March 10, 2022

**Re: Comment on Sustainable Communities Environmental Assessment (SCEA)
Lucia Park Project (620 N. Brand Boulevard and 625 N. Maryland Avenue)**

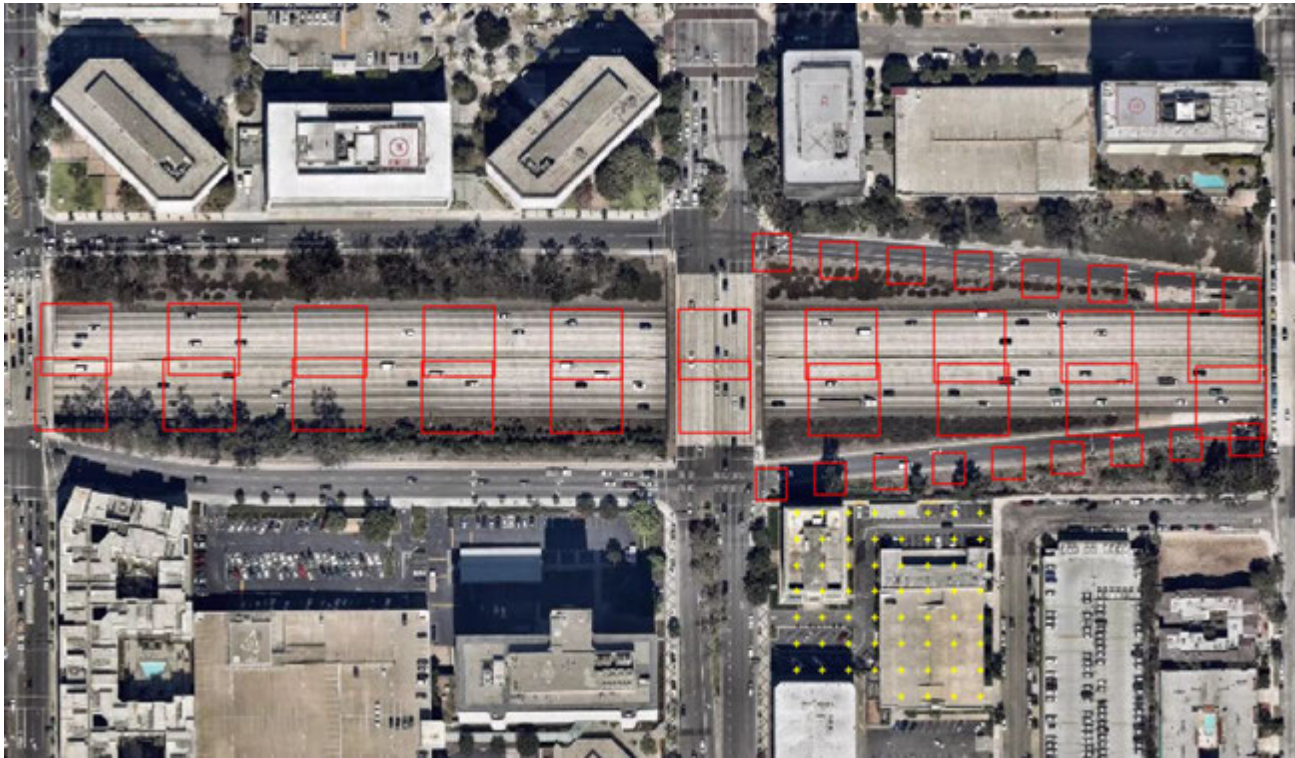
1. The Description Of The Air Dispersion Model In Appendix B Is Vague And Has A Number Of Omissions/Errors The Must Be Corrected.

After reconstructing the AERMOD dispersion model from the information compiled in Appendix B to the SCEA, it is clear that there are several flaws in the description to the model presented in the Appendix. According to the text of Appendix B, the air dispersion modeling was conducted using the American Meteorological Society/Environmental Protection Agency Regulator Model (AERMOD v. 10.0.1).¹ This reference is out of date. According to the July 2021 AERMOD Implementation Guide from U.S. EPA, the current version of AERMOD is 21112.² This would make the version utilized by the City more than a decade old, and would not have the capability to import background concentrations, calculate hourly emissions using multi-year assessments, or process large postfiles. If the reference to version 10.0.1 is to the graphical user interface (GUI) used to run AERMOD, the City must correct the text in the SCEA. Either way it is clear the author of Appendix

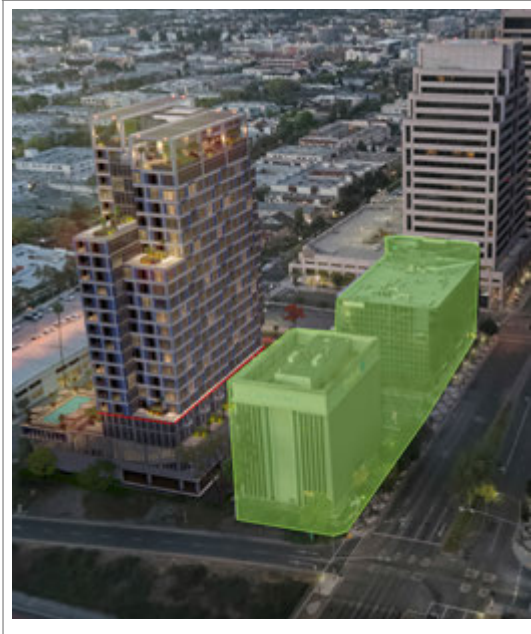
The proposed building at 24 stories would not “step down” as described to align with the existing cornices (see Figure 6). A string course or “a horizontal band... in a building forming a part of the design” is not a step, except on three bays at the slim north side which notably faces the freeway (*Merriam-Webster.com Dictionary*, Merriam-Webster, <https://www.merriam-webster.com/dictionary/stringcourse>. Accessed 9 Jan. 2022). In the section entitled “Building Design: Massing and Scale,” the Downtown Specific Plan directs in a diagram that “High rise massing should be divided to reduce overall bulk and step graciously down towards lower adjacent structures” (page 4-11). We see little stepping and no demonstrated evidence of design courtesy or deference toward the existing, low-rise historic resources.

Figure 8: Excerpted annotated section from page 53, “step” between the proposed 5th and 6th levels is circled in red (East-West Section 1). Home Savings Building is depicted at left. The wider volume below is the 1st-3rd floor base that is approximately 15 feet larger, shown as a red arrow.

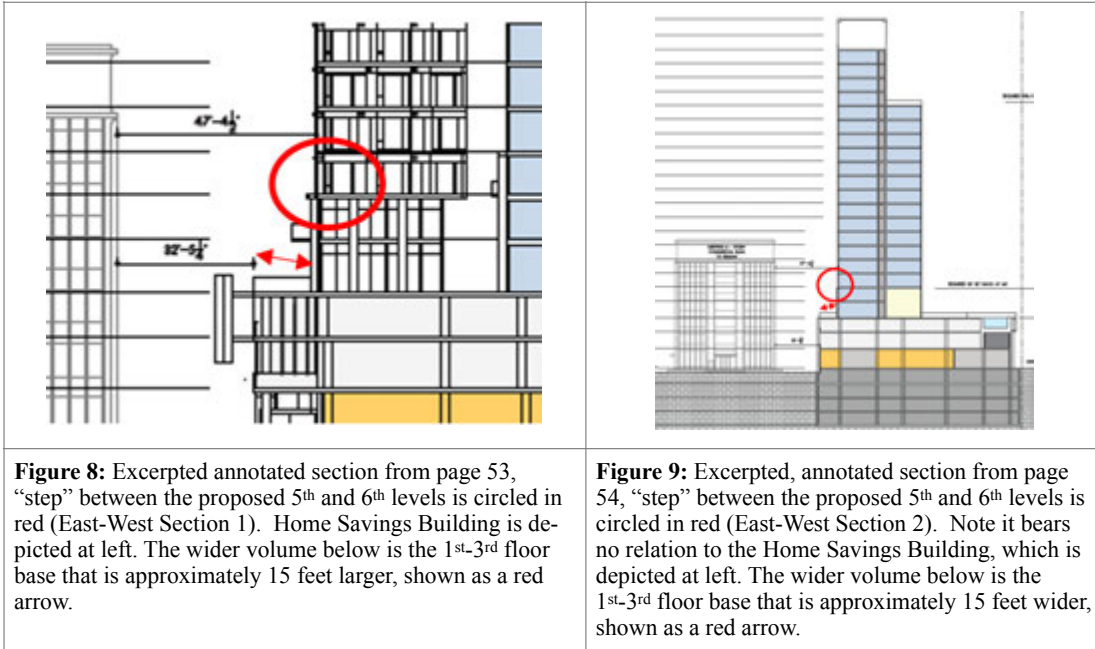
Additional details of the proposed “step” in the proposed project In Figures 8 and 9, and on pages 53, 56 and 57 of Exhibit 1, Stage II Final Design Review Packet reveal that the step it is no more than a difference in materials, applied at the same depths, embellished by a horizontal band. The proposed step is more window dressing than a demonstrable difference in dimension.

Figure 9: Excerpted, annotated section from page 54, “step” between the proposed 5th and 6th levels is circled in red (East-West Section 2). Note it bears no relation to the Home Savings Building, which is depicted at left. The wider volume below is the 1st-3rd floor base that is approximately 15 feet wider, shown as a red arrow.

Figure 2: Excerpt from north elevation of [previously] proposed project. Annotation shows historic resource in yellow, with less than a window bay’s width separating the over-scaled new tower, and its 9-11th floors overhanging the historic property at the red arrow.

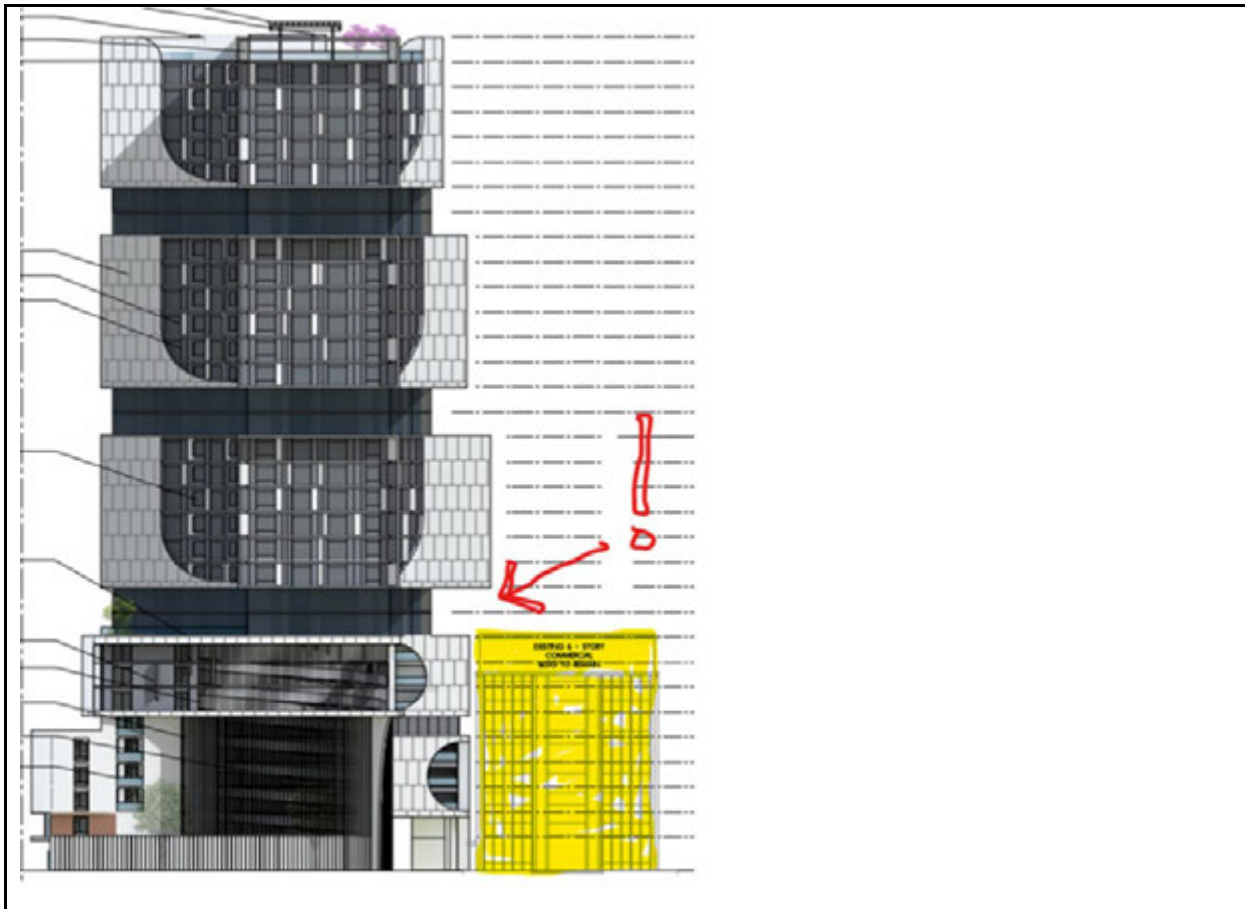
The historic tower would only be visible from the west as currently designed. The proposed project as designed is too close, and would loom over the main building (see Figure 2).

Figure 3: Excerpt from East Elevation, page 57. Note the parsimonious difference in heights on the left and right three bays. Source: Lucia Park 625 Maryland Ave, Glendale CA Stage II Design Review by John Freidman Alice Kimm Architects, 2019, not for publication (Lucia Park).

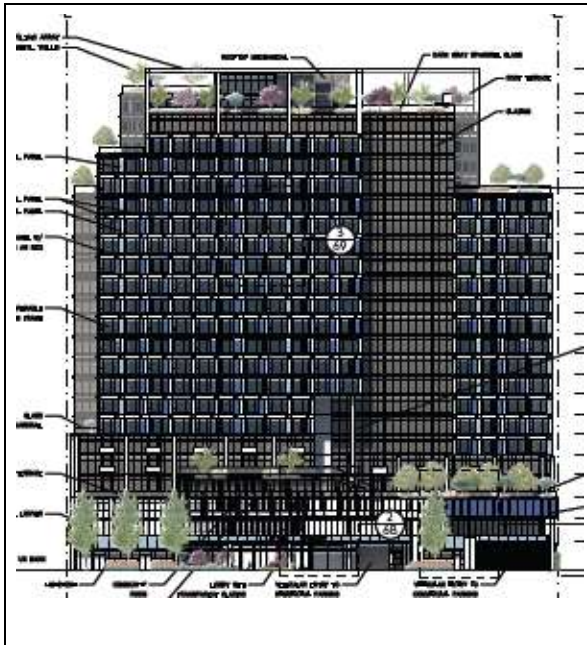
Articulation emphasizes the different visible aspects of the various parts of a building. Sometimes the effect completely obscures the sense of the whole, breaking it down into too many pieces, but in most cases, articulation creates a balance between the two. Articulation can also be expressed in recessed bays, which require giving up small amounts of valuable real estate. The modest articulation in the following figures emphasize the proposed building's nearly indefinable parts (Figure 1). There are three basic components, the base, equal and repetitive “grid” bay types on the left and right sides and the off-center, top and far left bays proposed as “dark gray spandrel glass.” The only visible proposed enunciation of components, other than the obvious differences in materials, is in the difference in heights at the top floors of the proposed project, see Figures 3, 4, 5 and 6.

Figure 4: Excerpt from South Elevation, page 58. Note the limited heights on the left and right bases (one or two bays). There is no recognition of the Home Savings Building’s frieze or of its termination in lower middle section of the addition. The Fidelity Savings Building at 600 North Brand Boulevard, a historic resource which is six stories high is not depicted. Source: Lucia Park.

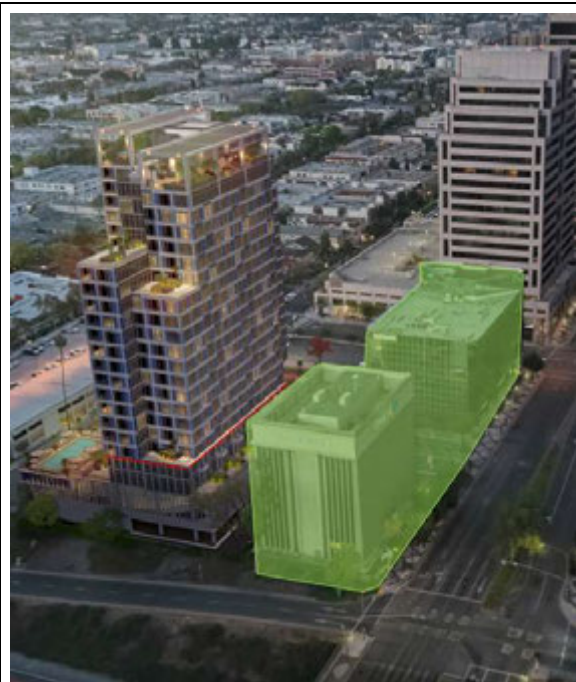
The proposed building at 24 stories would not “step down” as described to align with the existing cornices (see Figure 6). A string course or “a horizontal band... in a building forming a part of the design” is not a step, except on three bays at the slim north side which notably faces the freeway (*Merriam-Webster.com Dictionary*, Merriam-Webster, <https://www.merriam-webster.com/dictionary/stringcourse>. Accessed 9 Jan. 2022). In the section entitled “Building Design: Massing and Scale,” the Downtown Specific Plan directs in a diagram that “High rise massing should be divided to reduce overall bulk and step graciously down towards lower adjacent structures” (page 4-11). We see little stepping and no demonstrated evidence of design courtesy or deference toward the existing, low-rise historic resources.

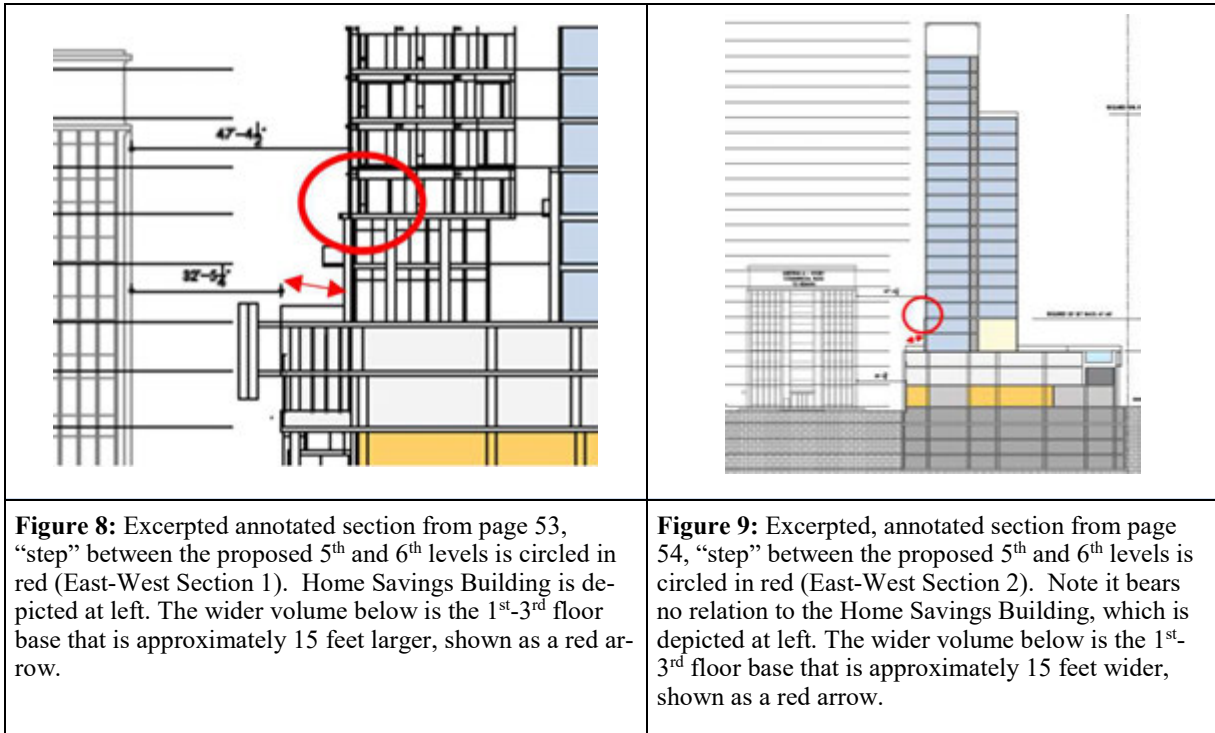
Additional details of the proposed “step” in the proposed project In Figures 8 and 9, and on pages 53, 56 and 57 of Exhibit 1, Stage II Final Design Review Packet reveal that the step it is no more than a difference in materials, applied at the same depths, embellished by a horizontal band. The proposed step is more window dressing than a demonstrable difference in dimension.

What review of the design packet reveals is that the proposed project steps “away” from the Home Savings Building by fewer than 15 feet, which is less than the length of standard parking spaces (red arrows, Figures 8 and 9). What the proposed project would actually “step back” from are the low-rise buildings on the east side of Maryland Avenue, by 20 feet (just 2 feet longer than a standard parking space).

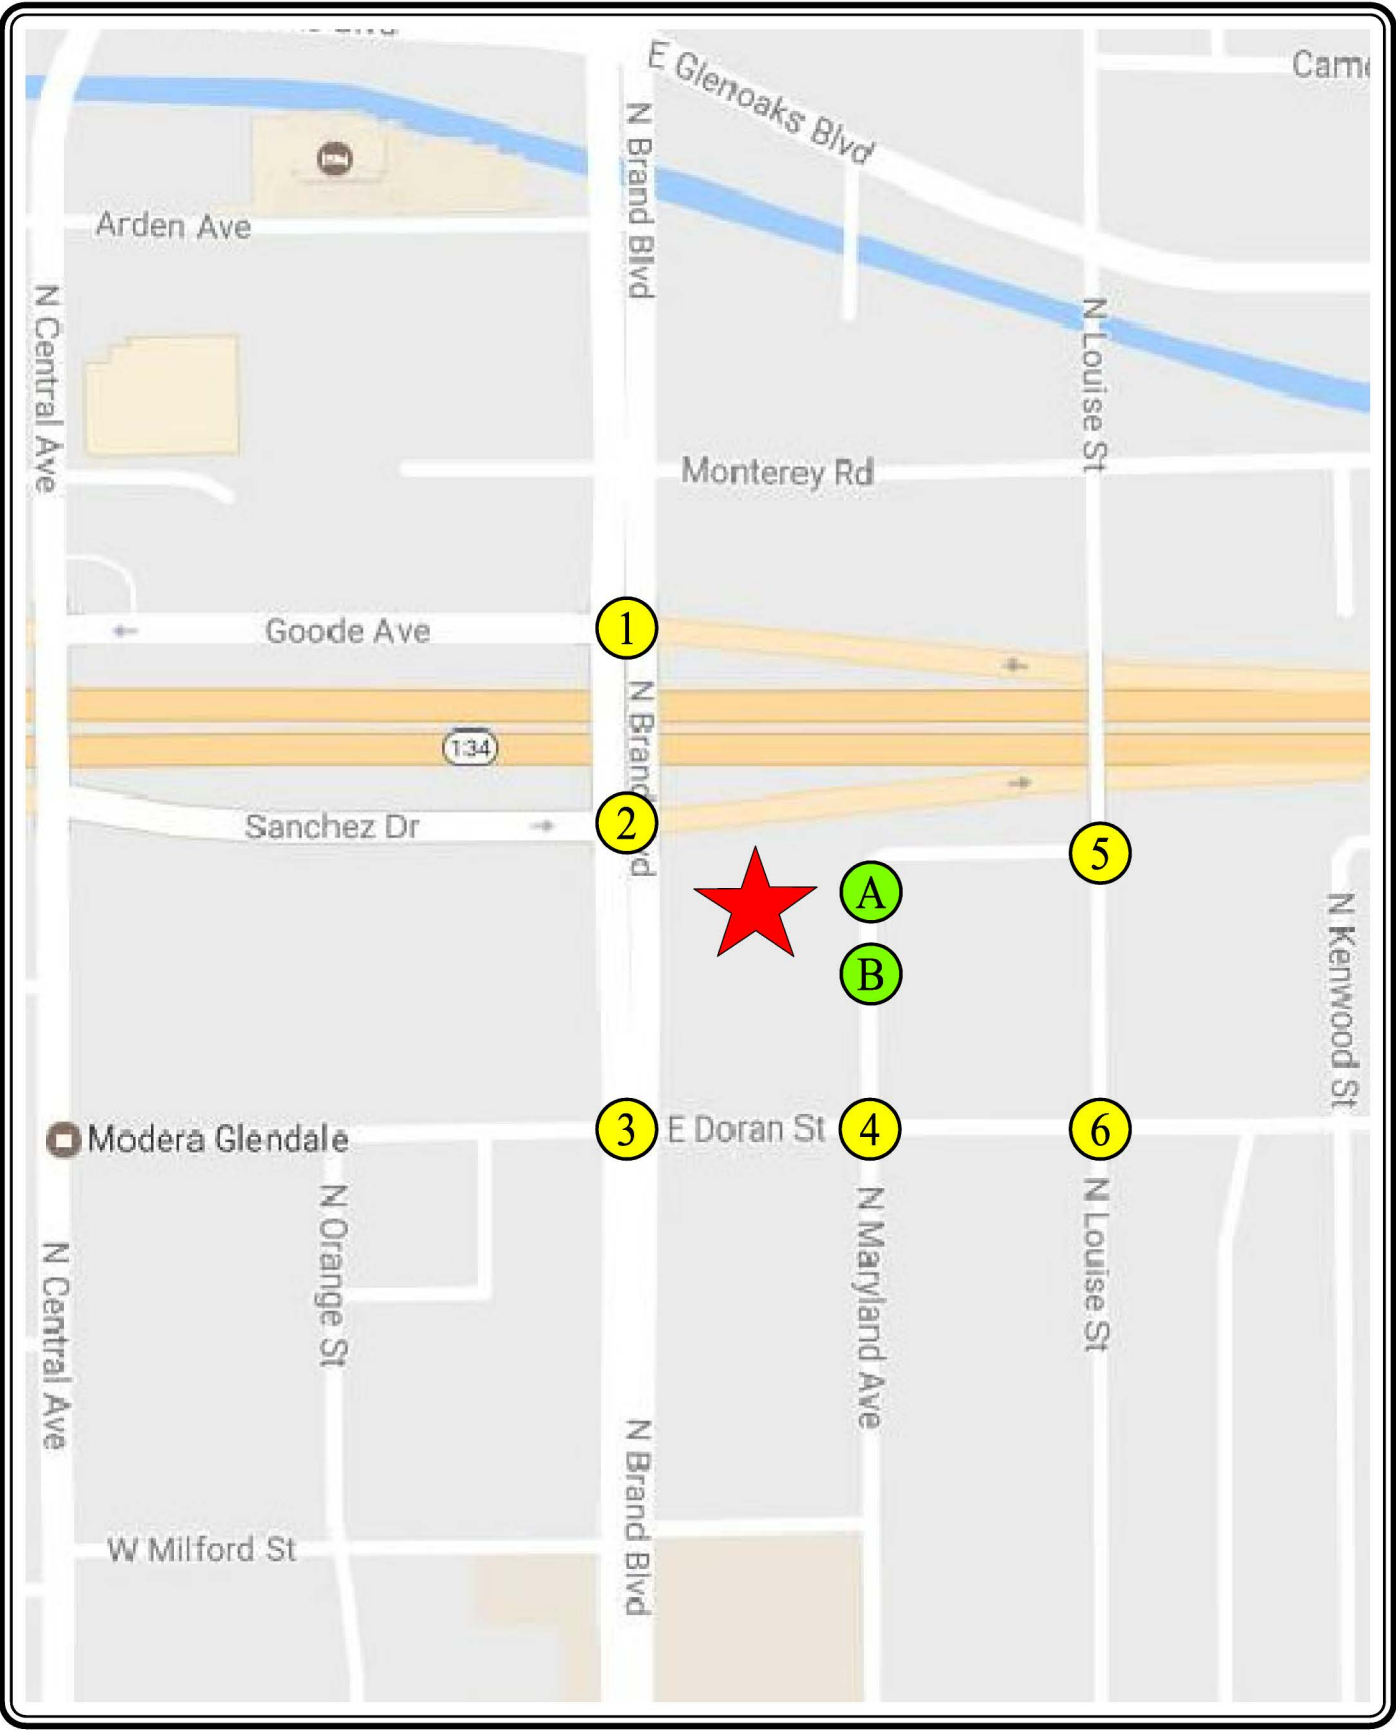
- 8. -Figure 8-4 **Net New Project Traffic Volumes-** Please clarify, the traffic volume does not add up at the 1 and 2 intersection 6-9

Figure 8–4 (Net New Project Traffic Volumes – Weekday PM Peak Hour) – Please clarify, the traffic volumes do not add up at Intersections 1 and 2.

The comment asks to clarify the traffic volumes at Intersections 1 and 2 in Figure 8-4. As discussed in Response to Comment 8 in **Appendix B**, the traffic volumes at Intersection 1 and 2 add up. As stated in

The traffic volumes at Intersection Nos. 1 and 2 do add up. As shown in Figure 8–4, a total of four (4) vehicles arrive at Intersection 1 from Intersection 2. Similarly, 16 vehicles arrive at Intersection 2 from Intersection 1. As stated in Section 8.2 of the TIA, the traffic volume assignments presented in Figure 8–4 reflect the traffic distribution characteristics shown in Figure 8–1 (Project Trip Distribution – Existing Site) and Figure 8–2 (Project Trip Distribution) applied to the Project traffic generation forecast presented in Table 8–1 (Project Trip Generation). There are instances where volumes arriving/departing from one intersection may not add up with volumes arriving/departing at an adjacent intersection due to rounding, as well as differences in site access points between the existing site and the Project.
